Subject: Safety Recall 05V-515
(Ford Number 05S37)

SUBJECT: Safety Recall 05S37:
Certain 2005 Model Year Five Hundred, Montego, and Freestyle Vehicles
Fuel Tank Strap Replacement

CERTAIN 2005 MODEL YEAR FREESTYLE, FIVE HUNDRED AND MONTEGO MODELS — FUEL TANK STRAP REPLACEMENT

FIGURE 1

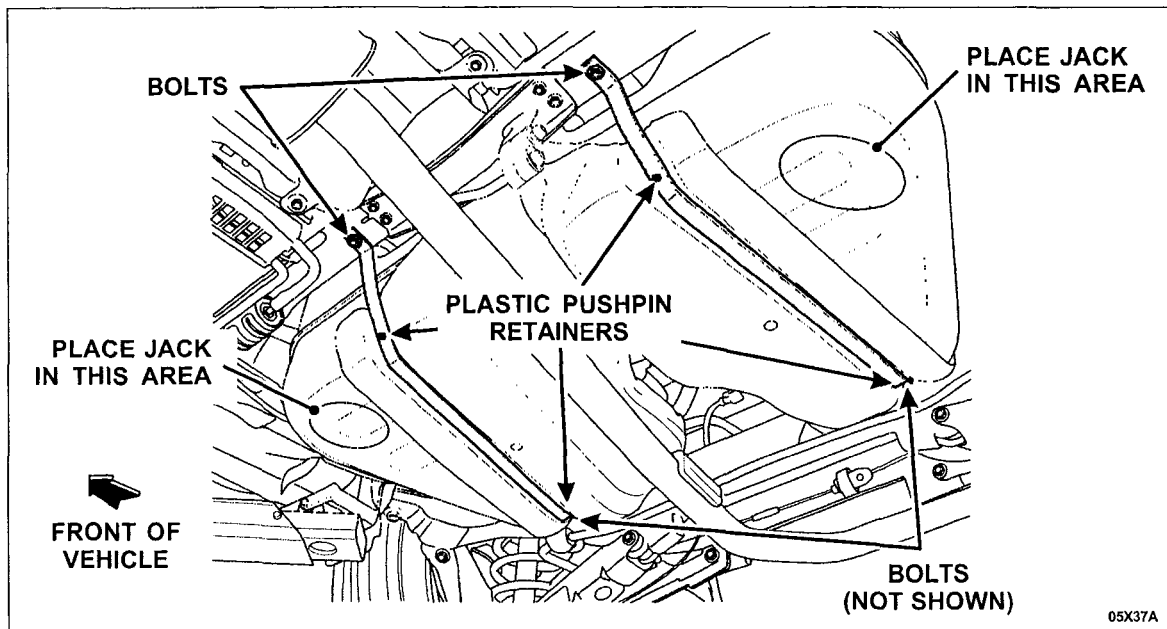
1. NOTE: It is not necessary to drain any fuel from the tank before disconnecting the filler tube from the fuel tank even if it is full. Fuel will not spill if the vehicle is raised level on a hoist.
On Five Hundred and Montego FWD models only, disconnect the fuel filler tube from the fuel tank.
2. Position a tall jackstand under the right side (passenger side) of the fuel tank to support its weight. Do not place the stand under the heat shield.
3. Using side cutters, cut off the two (2) plastic pushpin retainers protruding through the heat shield and tank strap. See Figure 1.
4. Remove the fuel tank strap bolts and remove the strap from the vehicle. On Five Hundred and Montego FWD vehicles, **discard the REAR bolt only**. See Figure 1.

5. Remove and discard the heads of the plastic pushpin retainers from above the heat shield.
6. **CAUTION: Do not bend the straps during installation.**

CAUTION: The service kits for the Five Hundred and Montego FWD vehicles comes with a *new*, shorter rear bolt. The original rear bolts must be discarded.

Position a *new* strap in place and install the rear retainer bolt first, then the front bolt. Tighten the bolts hand tight at this time.

FIGURE 2

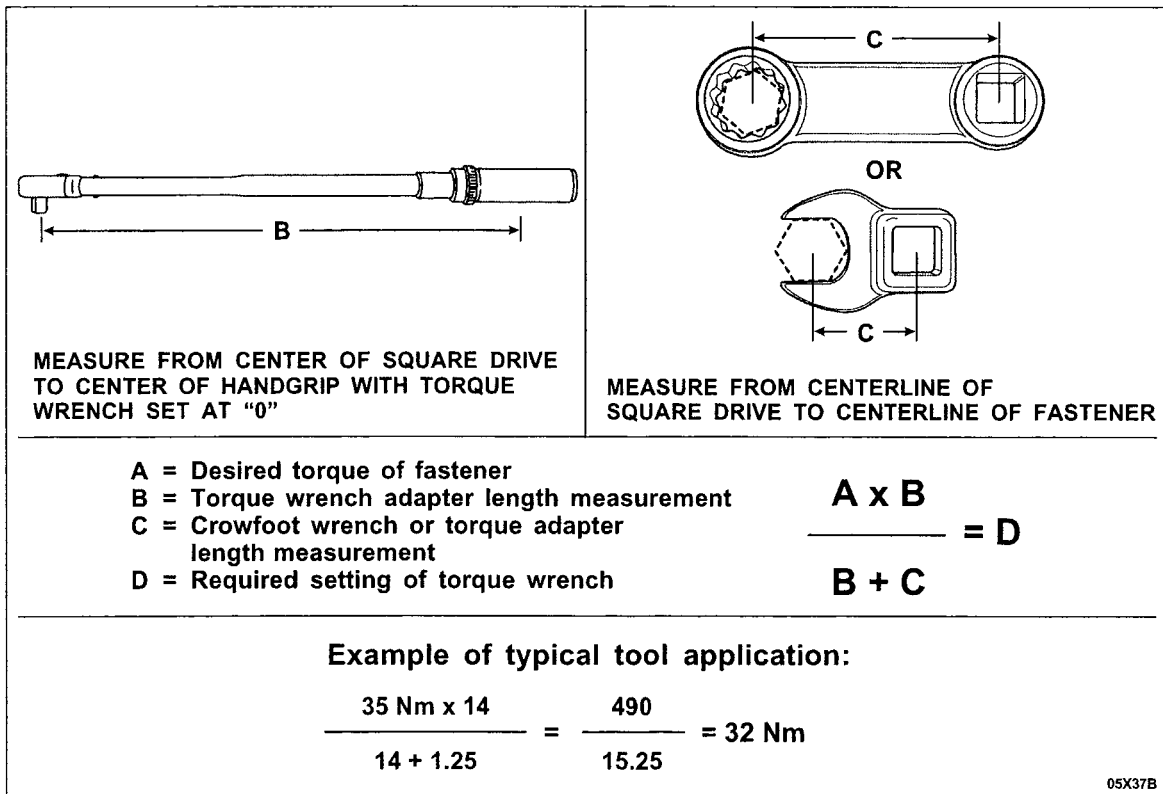
9. **CAUTION: Proper fuel tank strap bolt torque is critical to the performance of the straps.**

Tighten the bolts to 35 Nm (26 lb-ft).

Remember – Items such as deep sockets and torque wrenches vary greatly in size not only from manufacturer to manufacturer, but each manufacturer may offer different size wrenches as well. When using a crowfoot wrench or a torque adapter, calculate the proper torque wrench setting based on tool dimensions. See Figure 2.

- **Freestyle FWD** – tighten the bolts using a torque wrench and standard shallow socket.
- **Freestyle AWD** – tighten the bolts using a crowfoot wrench on an extension positioned in the pocket of the lower control arm-to-inboard pivot bushing.
- **Five Hundred / Montego FWD** – tighten the bolts using a torque wrench and a commercially available torque adapter positioned above the rear subframe.
- **Five Hundred / Montego AWD** – tighten the bolts using a torque wrench and a deep socket positioned above the rear subframe.
